Riley-Purgatory-Bluff Creek Watershed District

Board of Managers Regular Meeting

Wednesday, May 2, 2018

Project: Chanhassen, MN Panera Store #6038 – Demolition of existing building and parking area to construct one retail/commercial building along with appurtenant site work, utilities, stormwater management, and landscaping. Two bioretention features and a sump manhole with an in-line energy dissipater, to prevent resuspension of sediment, known as the Snout™ are proposed to provide stormwater quantity, quality, and rate control.

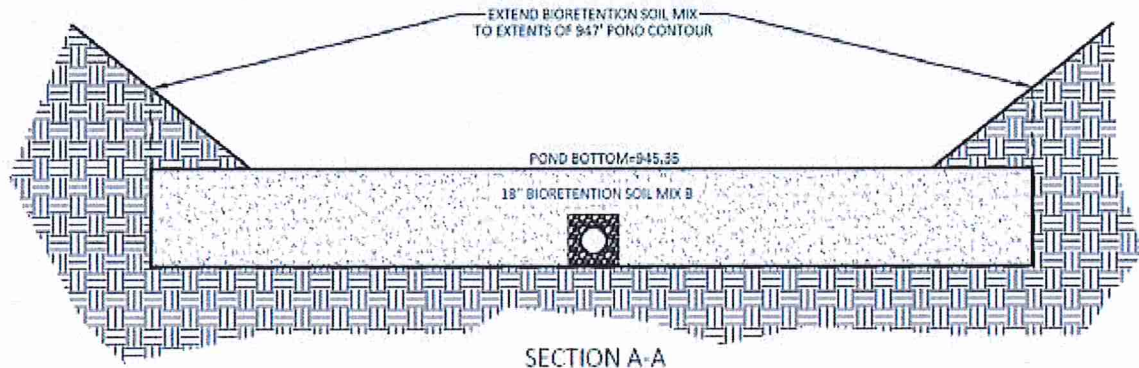
The applicant is positing that the site is restricted. The following information was presented to support this assertion.

1. All available green space on the property owned by the applicant, except where utilities conflict, will be utilized as a bioretention feature. See item 3 below.
2. The maximum depth that the bioretention features can provide for infiltration volume and still draw down in 48 hours is 0.24 feet. This means the capacity to provide additional infiltration volume is not available in the basins for meeting the requirement. The proposal does extend

the infiltration surface beyond the toe of slope. See exhibit below.

3. Borings advance under the parking lot to the east demonstrated, either because water was directly observed or soils indicators (redoximorphic features) were present that could only develop under saturated conditions. This means that underground practices would not be able to meet the requisite three (3) feet of separation to groundwater. This would also preclude the use of pervious pavers as an underdrain would be needed so no abstraction would occur.
4. The City of Chanhassen requires that they provide more parking stalls than they show. This creates an impediment to reducing the impervious surface on the site.

Engineering Associates, Inc.
PADERA BREAD
 EROSION CONTROL PLAN-PHASE 2

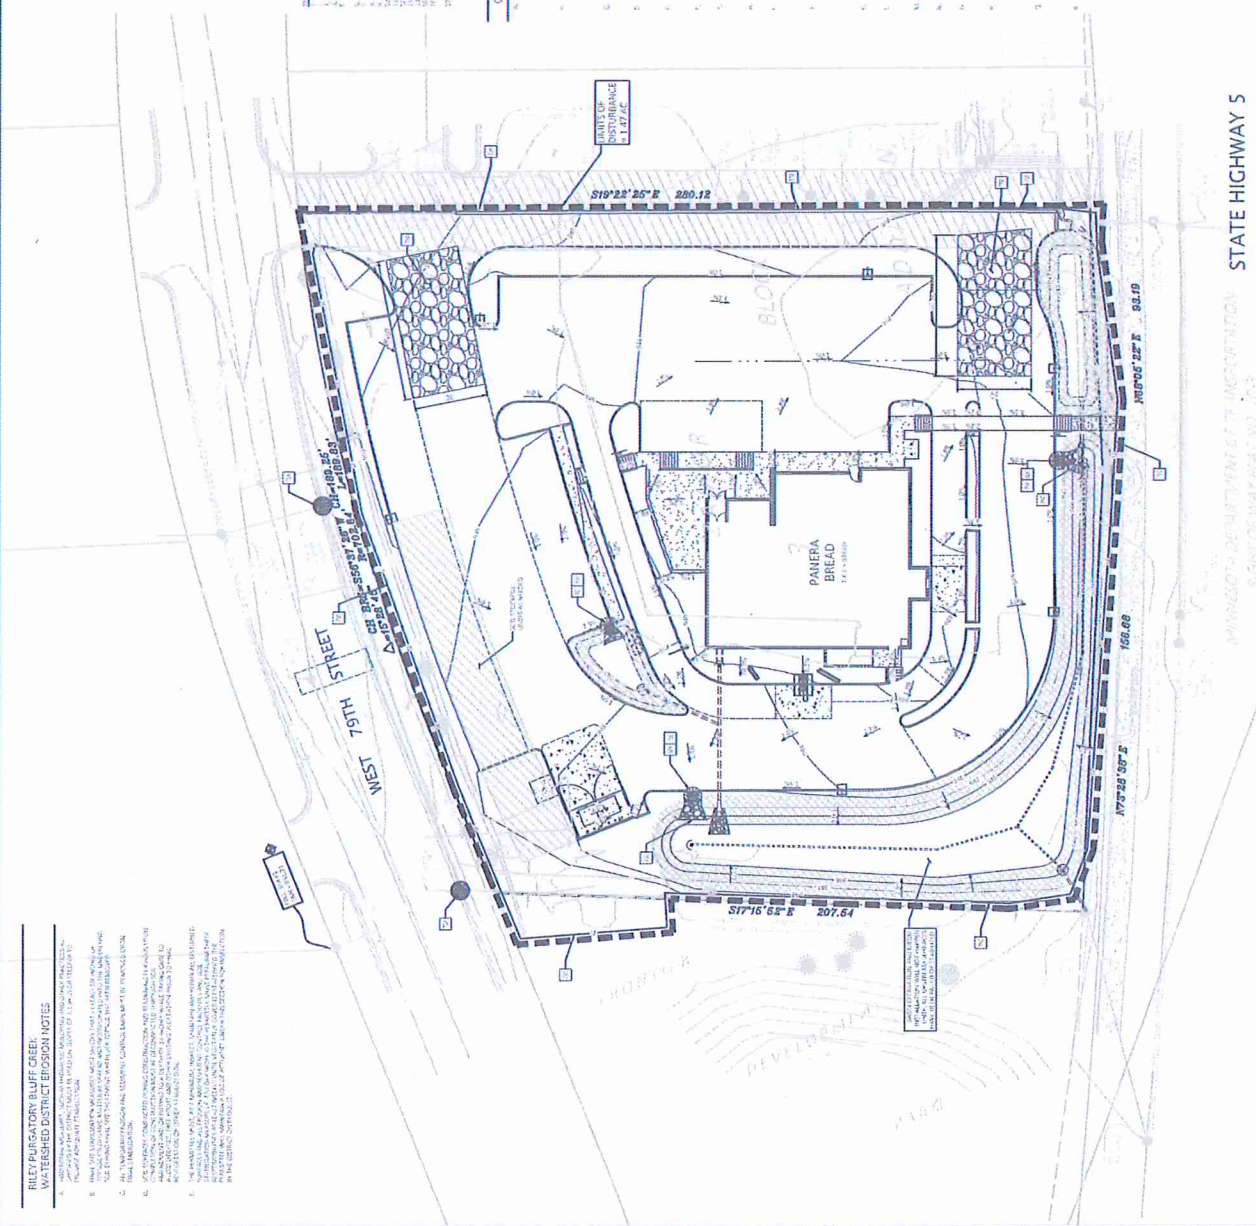
The erosion control plan prepared by CEI Engineering Associates includes installation of perimeter control where applicable, inlet protection for storm sewer catch basins, rock construction entrances, placement of a minimum of 6 inches of topsoil, decompaction of areas compacted during construction, and retention of native topsoil onsite. The contractor to be responsible for erosion control at the site needs to be determined. To conform to the RPBCWD Rule C requirements the following revisions are needed:

- C1. The Applicant must provide the name and contact information of the individual responsible for day to day erosion and sediment control inspection and maintenance at the site. RPBCWD must be notified if the responsible party changes during the permit term.

3. The Applicant must provide the name and contact information of the individual responsible for day to day erosion and sediment control inspection and maintenance at the site.
4. Receipt in recordation a maintenance declaration for the stormwater management facilities. A draft must be approved by the District prior to recordation.
